**BELOW-THE-HOOK LIFTING DEVICE**  
**Engineering Note Cover Page**

Device Name or Description: DΦ CFT lifting fixture

Engineering Note Prepared by: John Krider - JCK Date: 6/19/00

Engineering Note Reviewed by: Brent Andersson Date: 7/17/00

Dφ CFT installation  
Lift bracket weldment

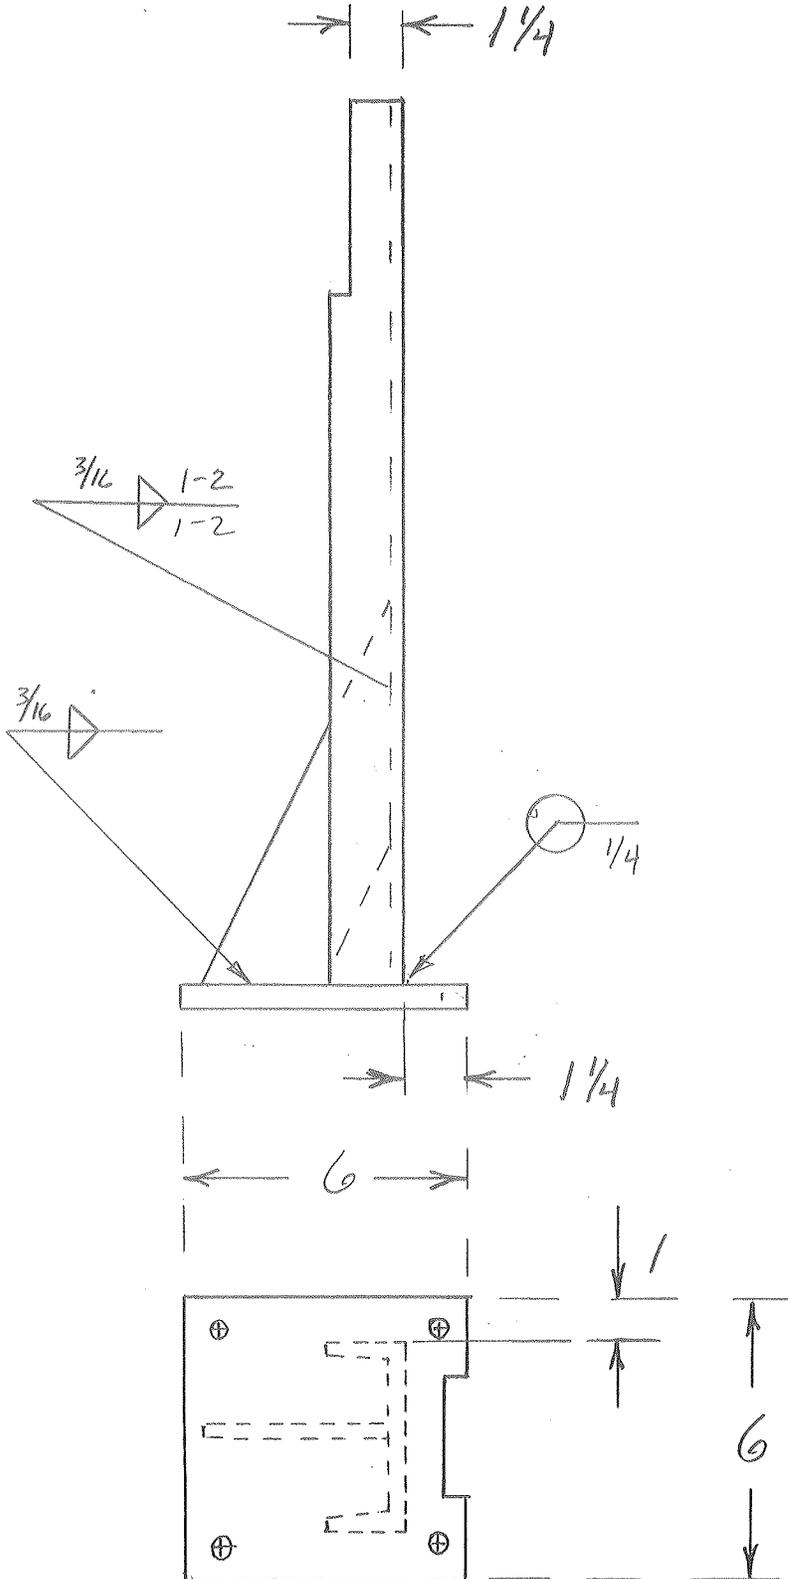
Date: Mon, 10 Jul 2000 15:59:41 -0500 (CDT)  
From: John Krider <krider@fnal.gov>  
To: banderso@fnal.gov  
Cc: krempetz@fnal.gov  
Subject: Correction to CFT lifting fixture weld stress calculation

The actual weld area at the base plate of the CFT lifting bracket column and gusset plate, as built with heavier gauge materials than originally requested, is:

$$(4+4+2.5+2+2.5+2 \text{ in}) \times (0.25 \text{ in}) \times (\cos 45 \text{ deg}) + (6.1 \text{ in}) \times (0.188 \text{ in}) \times (\cos 45 \text{ deg})$$
$$= 3.82 \text{ sqin}$$

So the average stress in the weld is:

$$(520 \text{ lb}) / (3.82 \text{ sqin})$$
$$= 136 \text{ lb/sqin}$$

Because of the geometry of the lifting fixture, the stress is not uniform at all points in the weld. The peak weld stress occurs along the web of the channel and is probably on the order of 20% higher than the average stress. Therefore, the peak stress is estimated to be 163 lb/sqin, still slightly less than the originally calculated value, and vastly below allowable weld stresses.
